Staff Summary Report

Development Review Commission Date: 03/22/11

SUBJECT: Hold a public meeting for a Development Plan Review for THE RETREAT AT 1000 APACHE located at 1000 East Apache Boulevard.

DPR11038 – Development Plan Review including site plan, building elevations, and landscape plan.

ROOF PLAN
1/8" = 1'-0" (24x36 SHEETS)

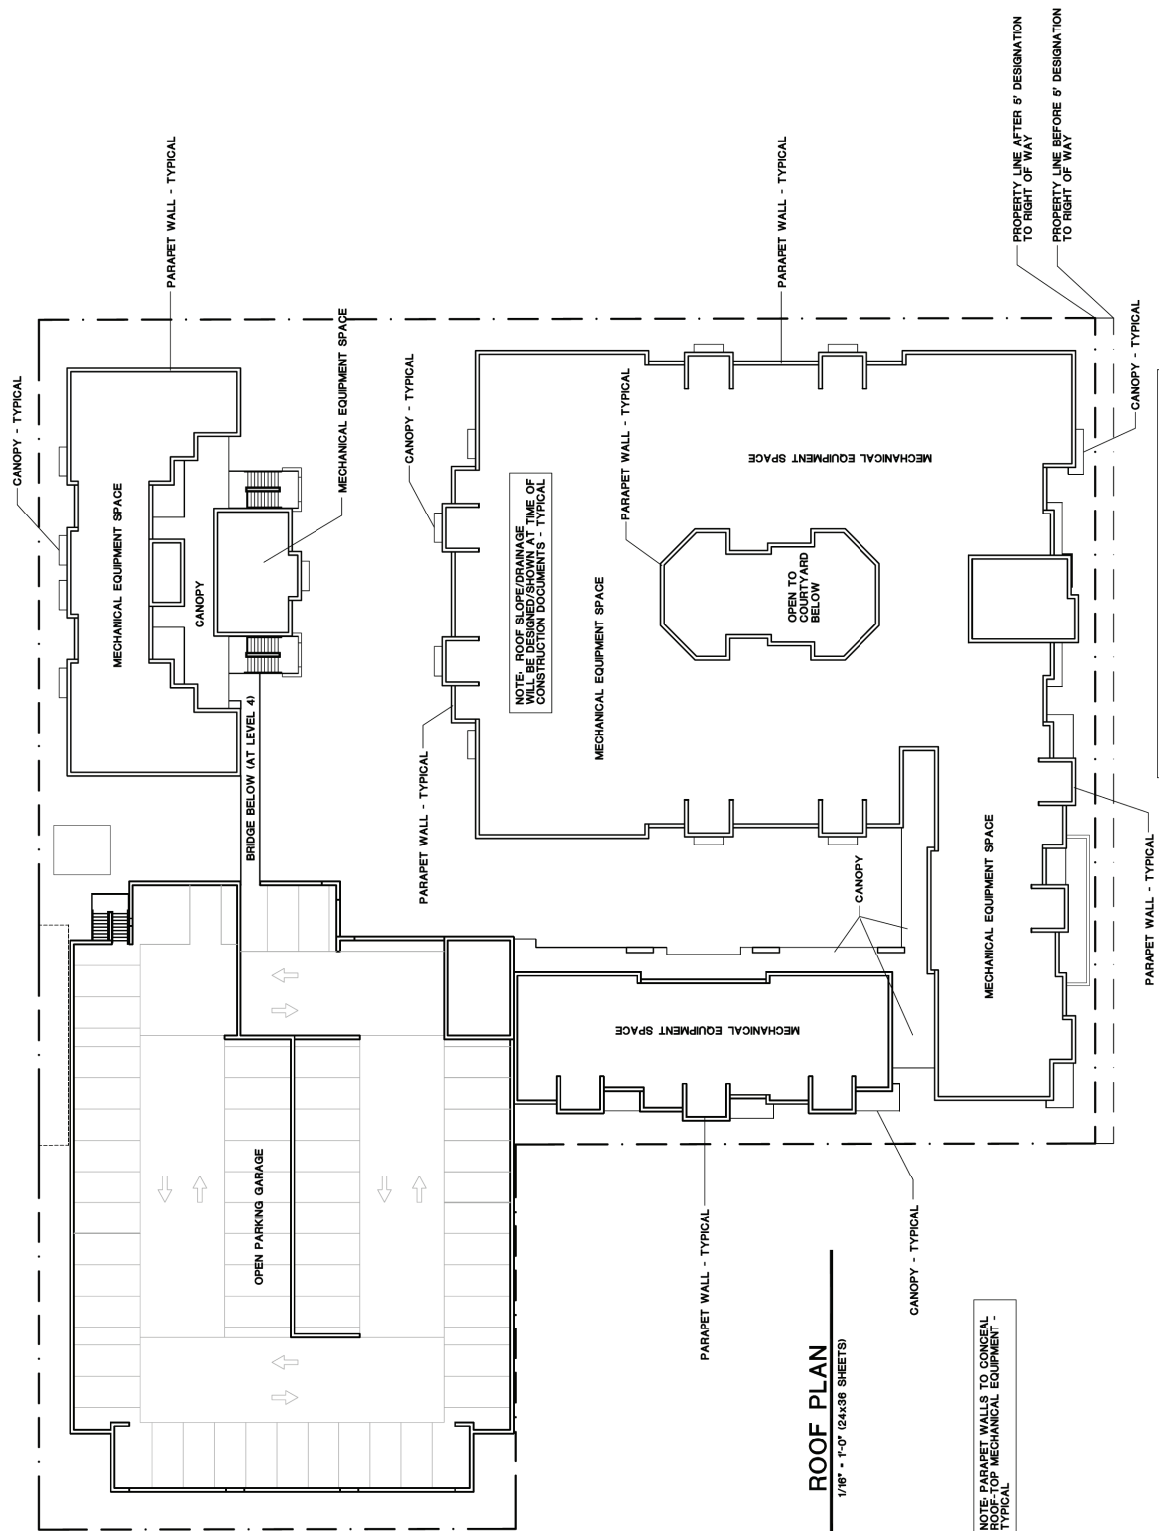
11. Provide secure roof access from the interior of the buildings to each roof. Do not expose roof access to public view, including ladders between adjacent roofs. Provide continuous parapets. Do not expose any portion of roof top equipment.

- Provide address sign on roof as indicated. Place sign on horizontal surface, with 6'-0" high address number and 3'-0" high street name. Provide characters of minimum 50 percent contrast with background. Do not illuminate sign.

PRELIMINARY LANDSCAPE PLAN

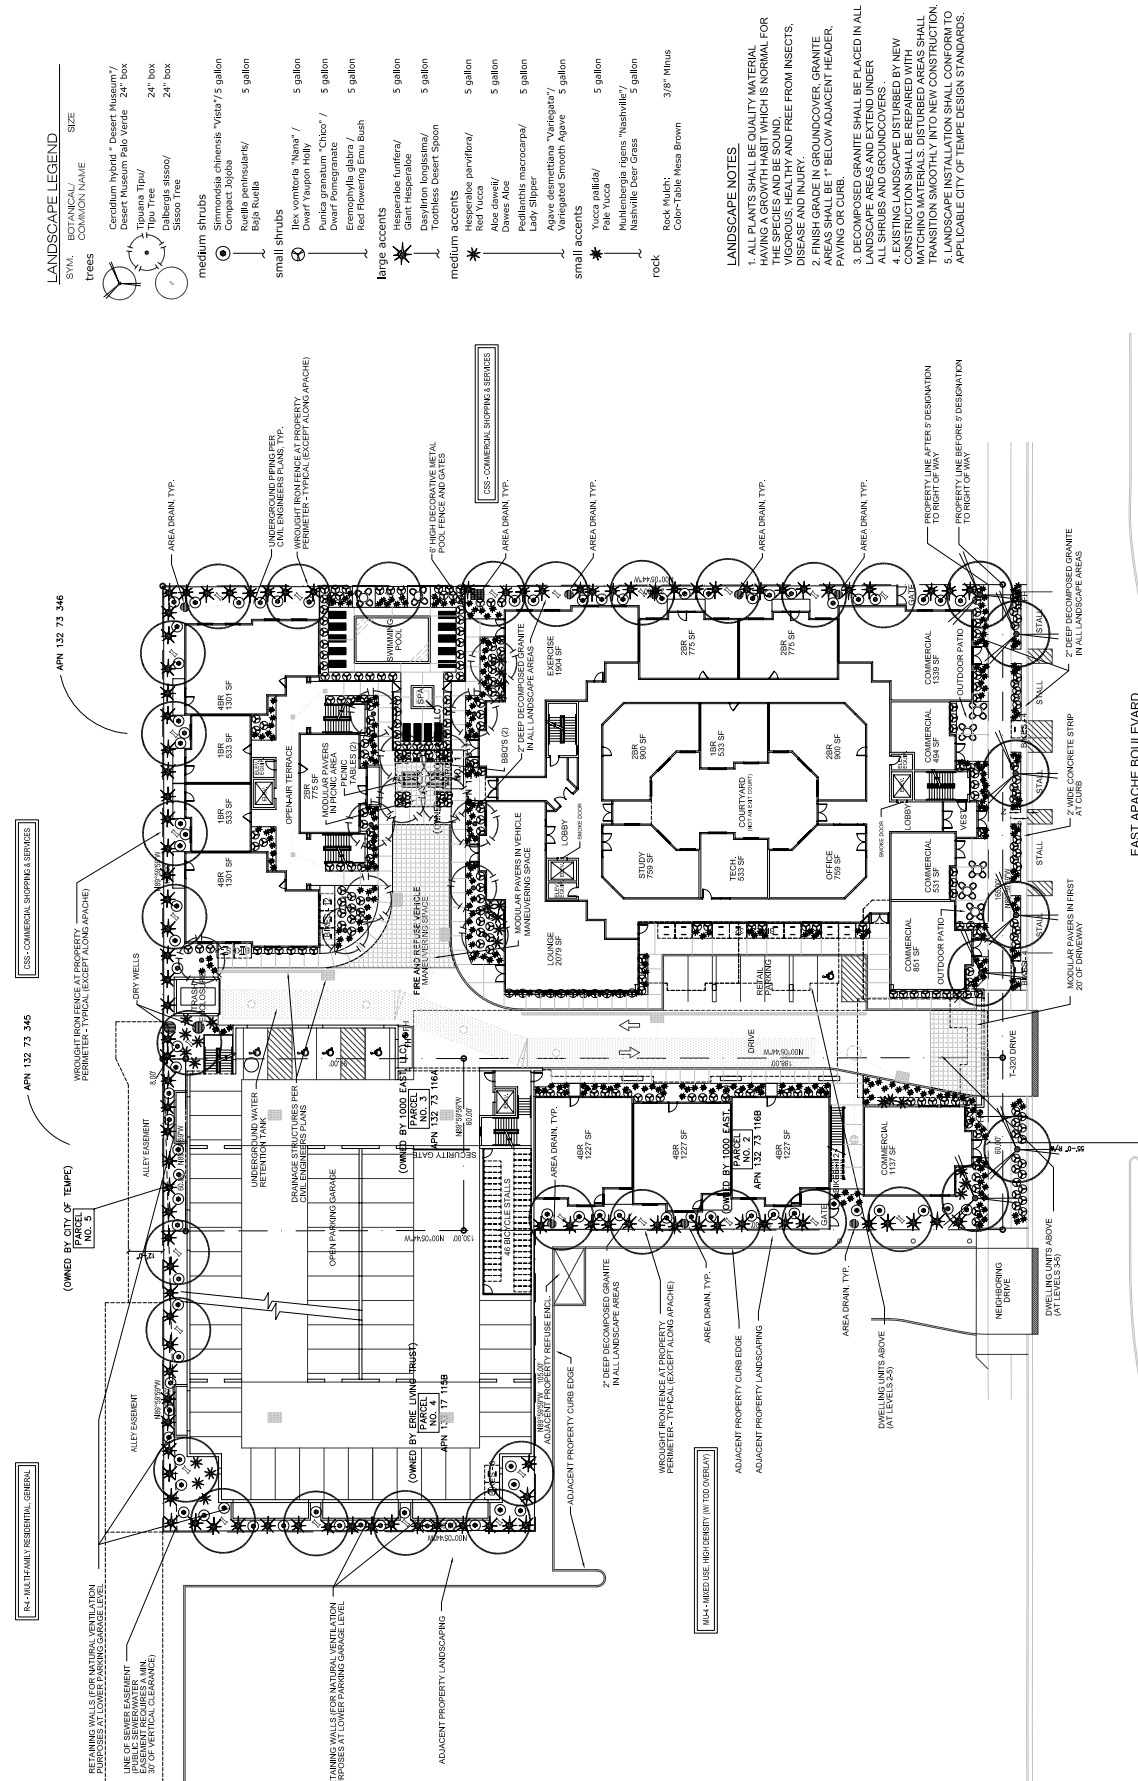
15. Landscape development standards as listed in ZDC Sec. 4-701 through 4-706 apply to this Mixed-Use District.
16. Select vine for lattice on garage that will thrive on northern orientation.

17. Maintain tree buffer as presented along east, west or north property lines, except reposition trees at north of garage to stay clear of the sewer easement extension. Coordinate position of subsurface retention structure along perimeter with tree placement so the trees are not sacrificed during construction document plan check process.

- DRIVEWAYS:
 - Construct driveway in public right of way per Standard Detail T-320.
 - Correctly indicate clear vision triangles at driveway on landscape plan. Identify speed limit for Apache Boulevard. Begin sight triangle in driveways 15'-0" in back of face of curb. Consult "Corner Sight Distance" leaflet, available from Cathy Hollow in Transit Studies (480-350-8445 catherine_hollow@tempe.gov) if needed. Do not locate site furnishings, screen walls or other visual obstructions over 2'-0" tall (except canopy trees are allowed) within each clear vision triangle.
